2023 JEBAVY DRIVE RECONSTRUCTION – US10 TO BRYANT

Addendum #2 – March 24, 2022

ADDENDUM #2

2023 JEBAVY DRIVE RECONSTRUCTION – US-10 TO BRYANT ROAD

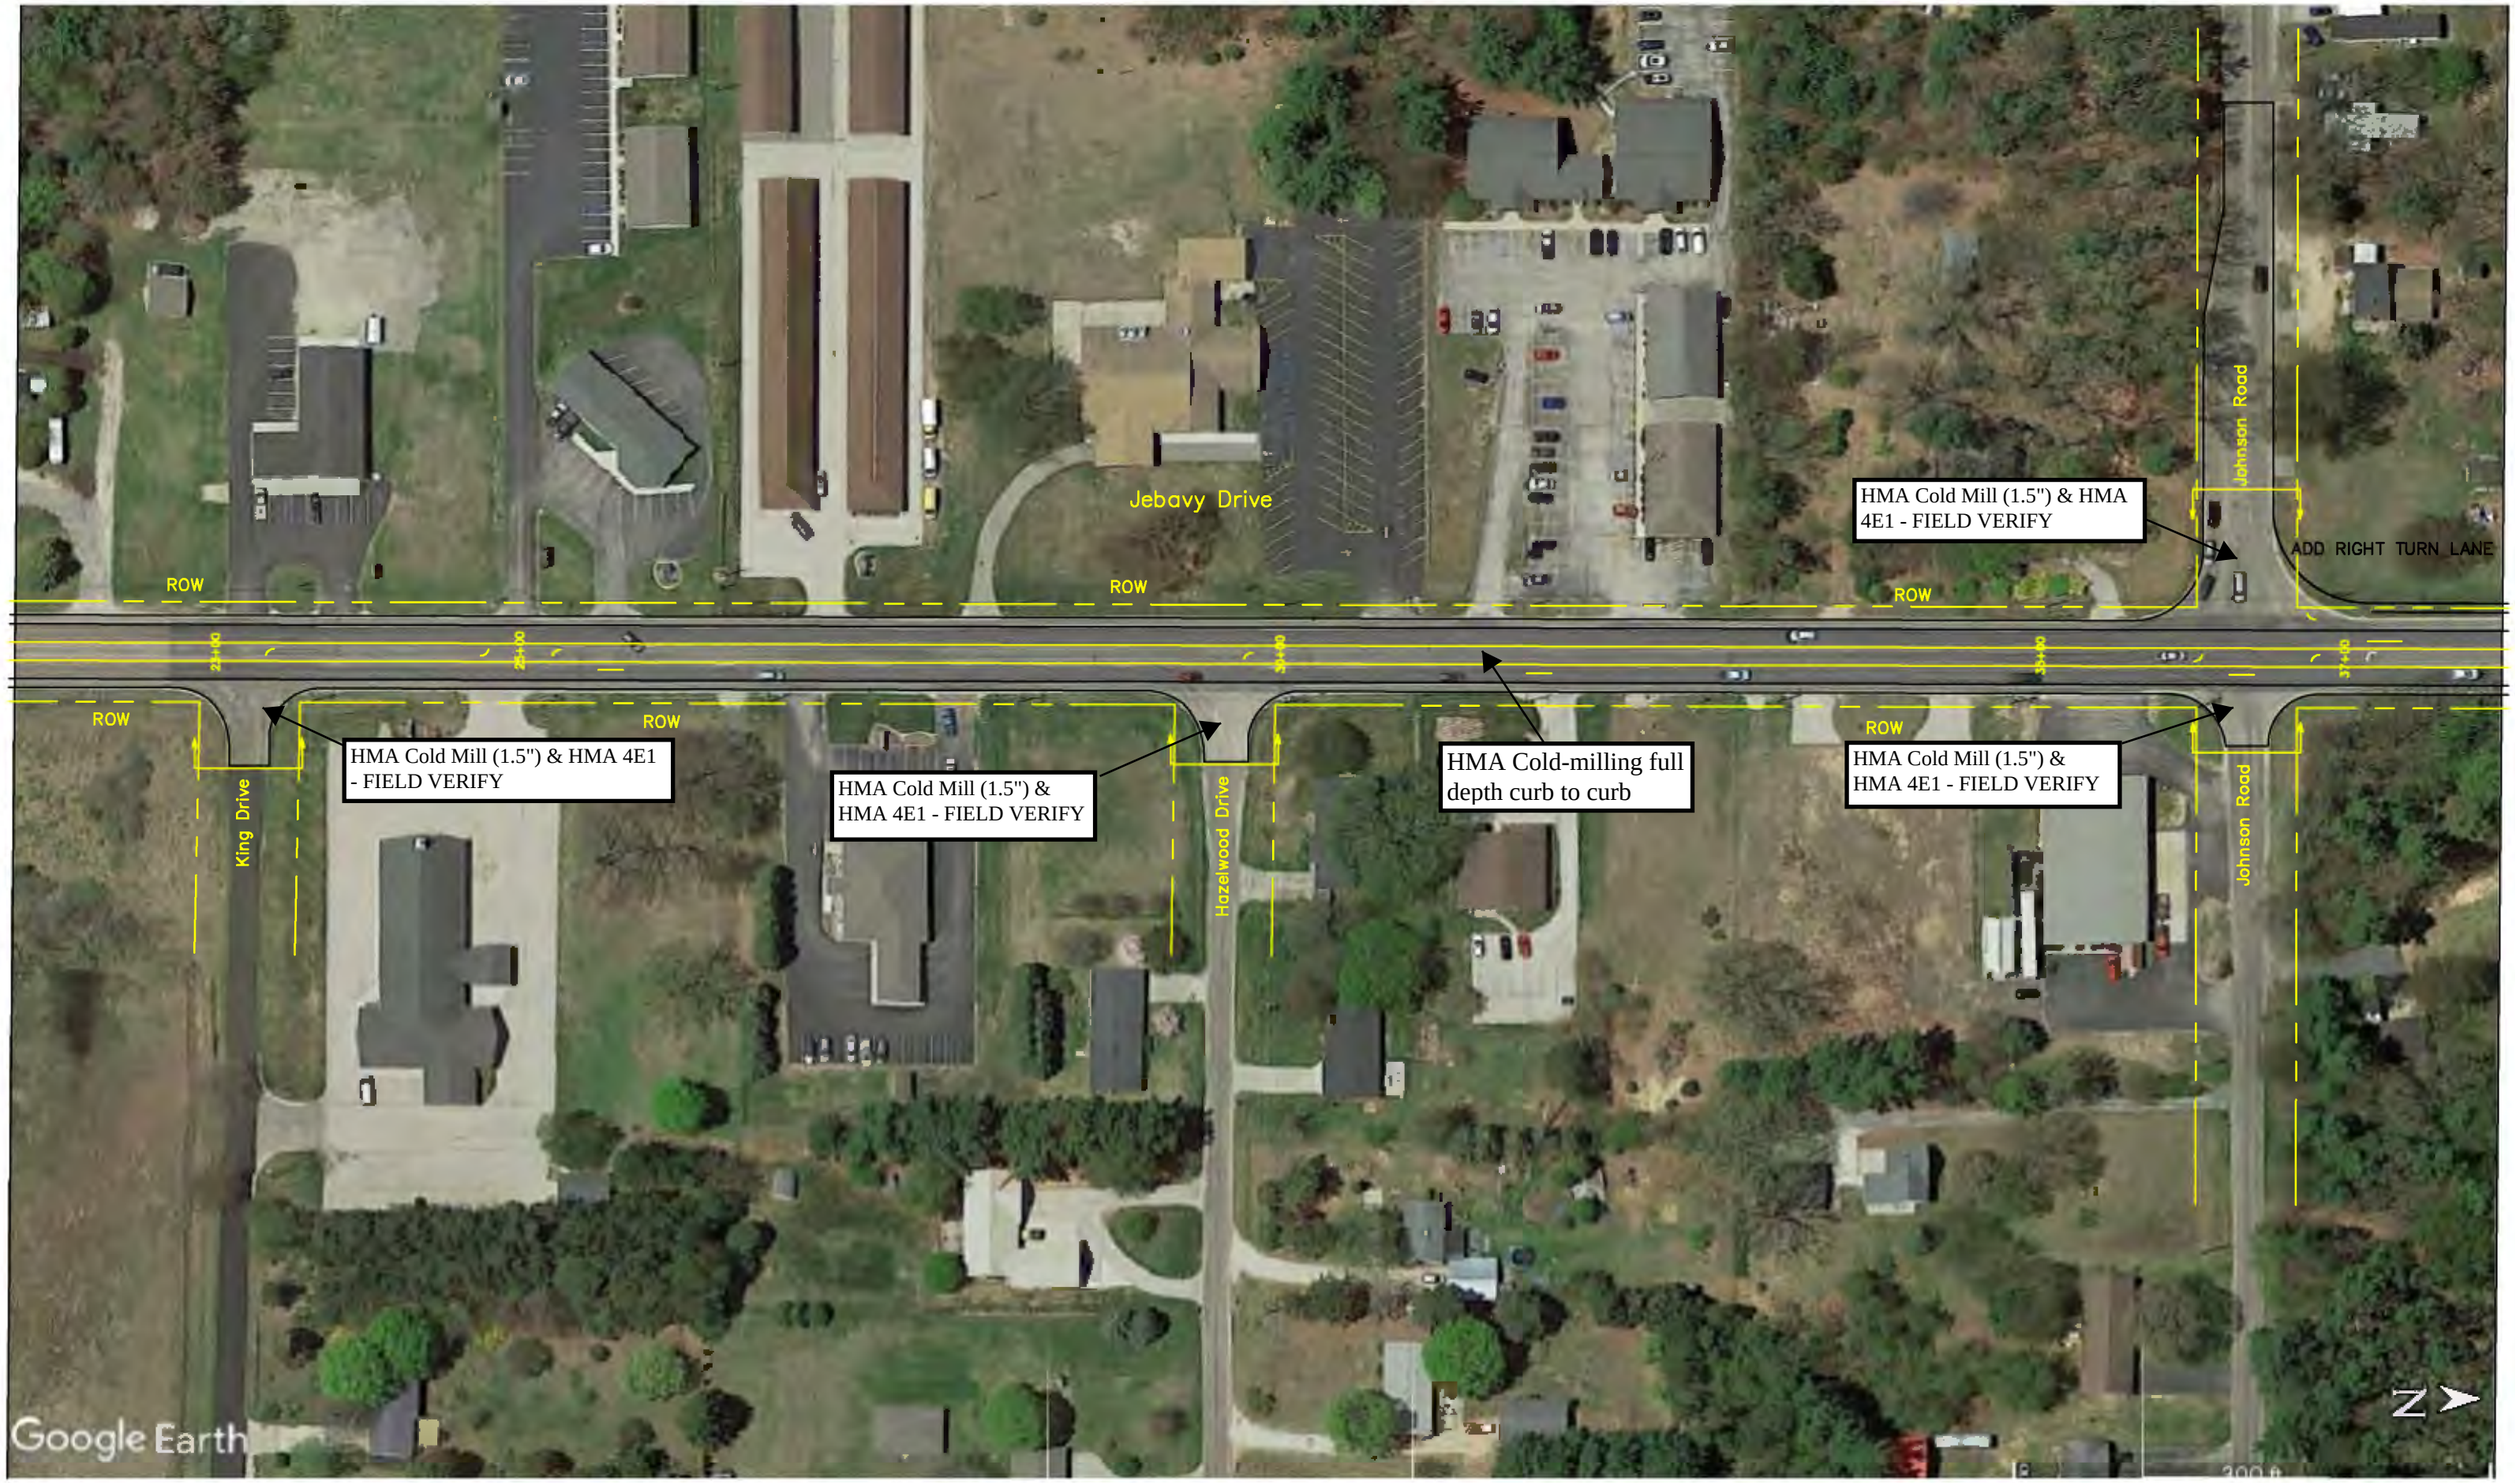
Jebavy Drive
HMA Cold-milling
full depth curb to curb
POB
ROW
ROW
ROW
ROW
US-10
10+00
P.O.B. 10+00
18+60
24+42
N Jebavy Dr
HMA Cold Mill (1.5") & HMA
4E1 - FIELD VERIFY
W King Dr
King Drive

Jebavy Drive
ROW
ROW
ROW
Johnson Road
HMA Cold Mill (1.5") & HMA 4E1 - FIELD VERIFY
ADD RIGHT TURN LANE
24+00
25+00
30+00
34+00
37+00
ROW
ROW
ROW
ROW
King Drive
Hazelwood Drive
Johnson Road
HMA Cold Mill (1.5") & HMA 4E1 - FIELD VERIFY
HMA Cold Mill (1.5") & HMA 4E1 - FIELD VERIFY
HMA Cold-milling full depth curb to curb
HMA Cold Mill (1.5") & HMA 4E1 - FIELD VERIFY
Google Earth
N

HMA Cold Mill (1.5") & HMA 4E1 - FIELD VERIFY
ADD RIGHT TURN LANE
HMA Cold-milling full depth curb to curb
HMA Cold Mill (1.5") & HMA 4E1 - FIELD VERIFY
Johnson Road
Jebavy Drive
ROW
37+00
38+00
45+00
50+00
51+00
Google Earth

Ludington Area Schools Elementary School Complex
Bryant Road (2021 Reconstruction & Add Center Turn Lane)
ROW
ROW
ROW
ROW
ROW
ROW
ROW
Jebavy Drive
HMA Cold-milling full depth curb to curb
DO NOT REMOVE HMA IN THIS AREA- TRAFFIC LOOPS FOR TRAFFIC SIGNAL
Extend Right-Turn Lane for New Elementary School Complex - not enough storage capacity
Google Earth
300 ft
N

Bryant Road (2021 Reconstruction & Add Center Turn Lane)
ROW
ROW
DO NOT REMOVE HMA THIS AREA - TRAFFIC LOOPS FOR TRAFFIC SIGNAL
POE
Jebavy Drive
ROW
ROW
ROW
ROW
ROW
ROW
ROW
ROW
ROW
HMA Cold-milling full depth curb to curb
Rasmussen Road (2021 Reconstruction)
Google Earth
300 ft

JEBAVY DRIVE AT BRYANT ROAD
TOPOGRAPHICAL SURVEY
OF PART OF
SECTION 11 & 12, TOWN 18 NORTH, RANGE 18 WEST
PERE MARQUETTE TOWNSHIP, MASON COUNTY, MICHIGAN

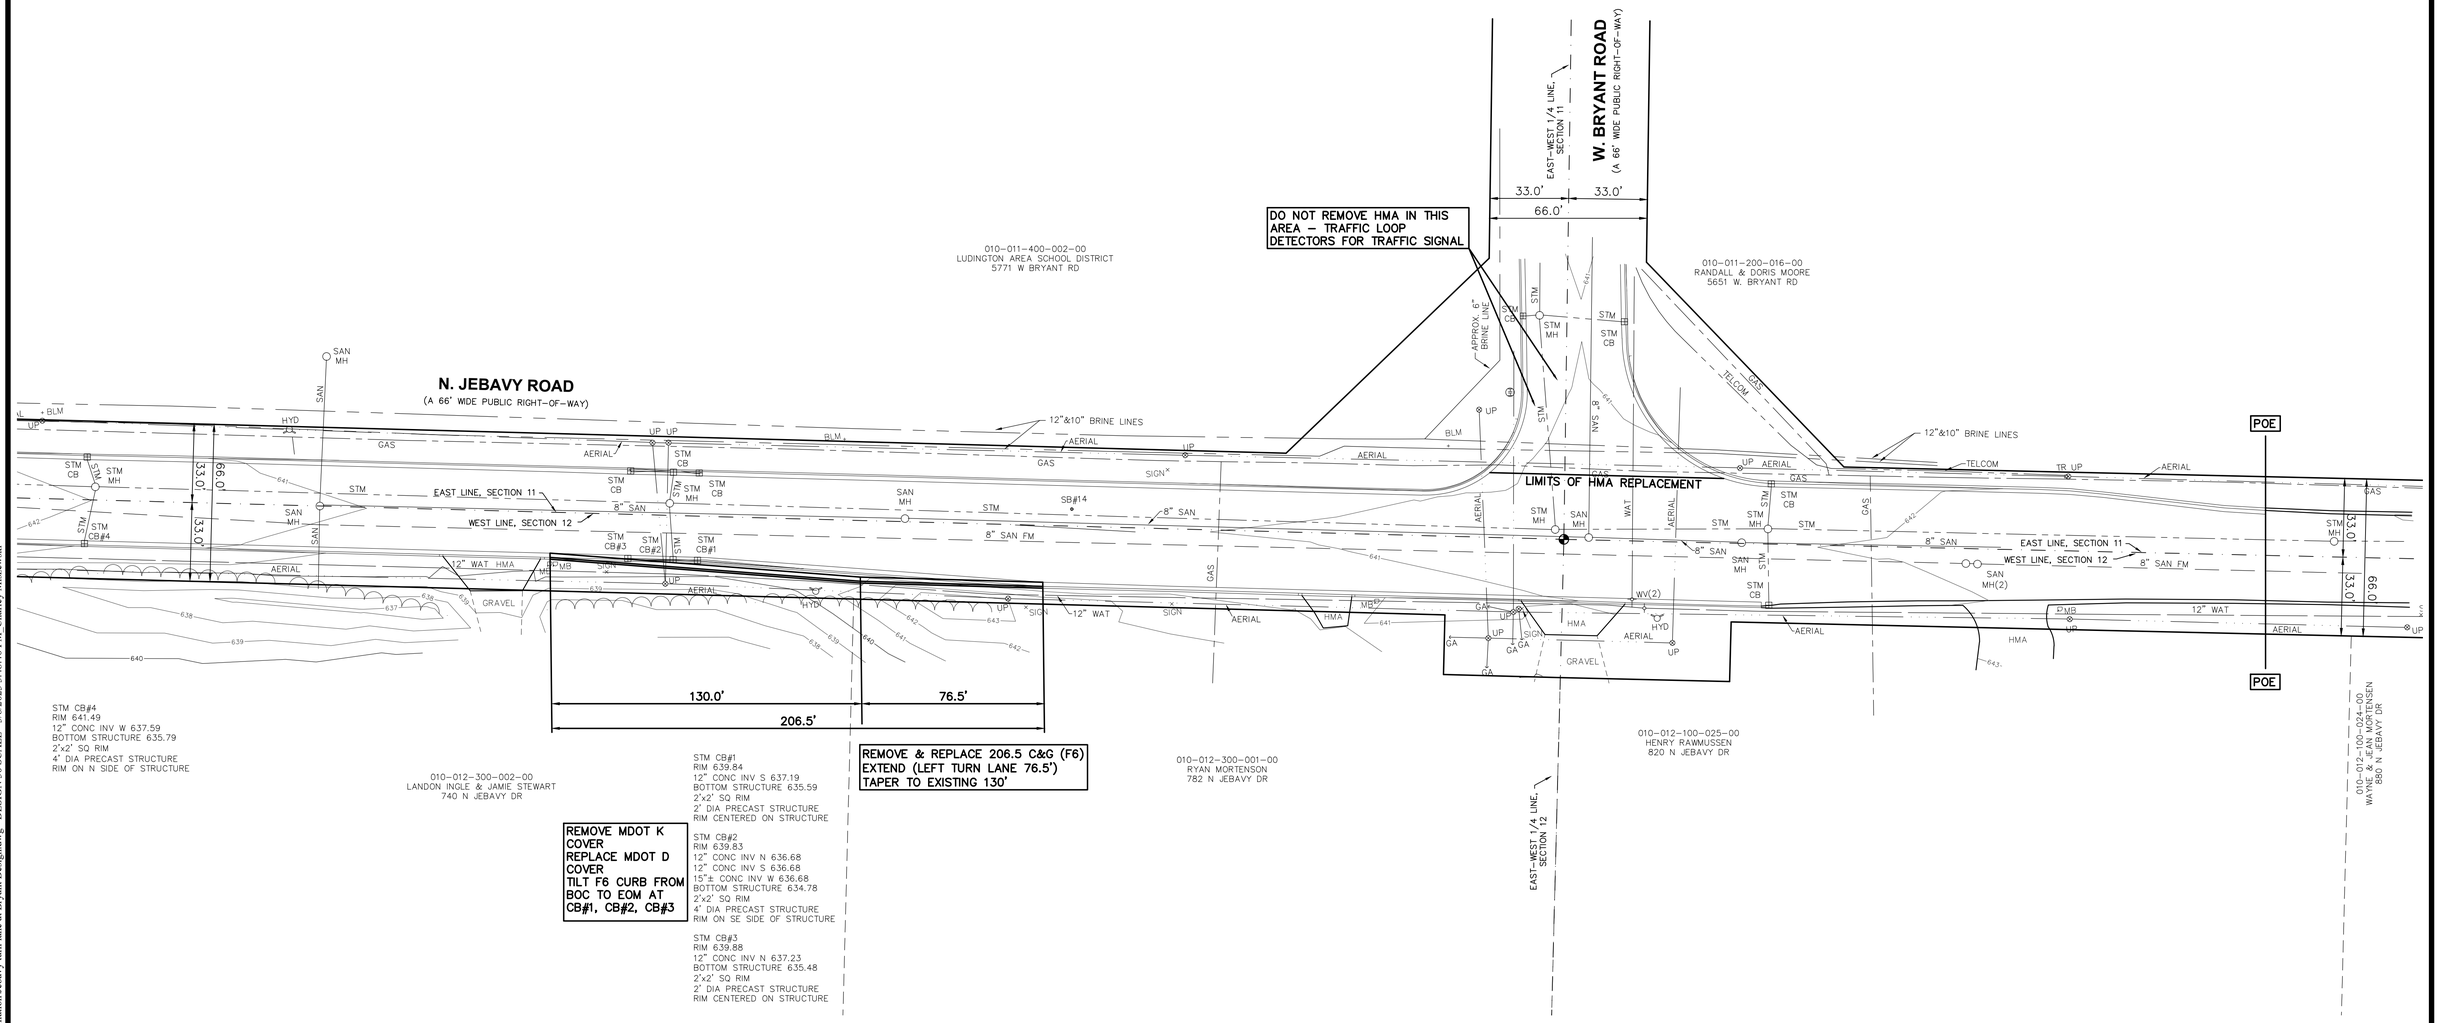
REMOVE
STM CB#1
RIM 642.39
12" CONC INV E 638.49
BOTTOM STRUCTURE 636.79
2'x2' SQ RIM
4' DIA PRECAST STRUCTURE
RIM ON S SIDE OF STRUCTURE

CB #1A – MDOT K Cover
Rim = 642.15
12" Inv. E = 638.50
BTM = 636.50

Place 18' of 12" SLCPP
(Verify inverts)

PROPOSED 12' WIDE
RIGHT-TURN LANE & C&G

REMOVE
STM CB#2
RIM 643.78
12" CONC INV S 640.48
BOTTOM STRUCTURE 638.63
2'x2' SQ RIM
4' DIA PRECAST STRUCTURE
RIM ON S SIDE OF STRUCTURE
OFFSET HALF WAY

CB #2A – MDOT K Cover
Rim = 643.50
12" Inv. SE = 640.58
BTM = 638.58

Place 19' of 12" SLCPP
(Verify inverts)

Remove and
replace 385' of
MDOT F6 C&G
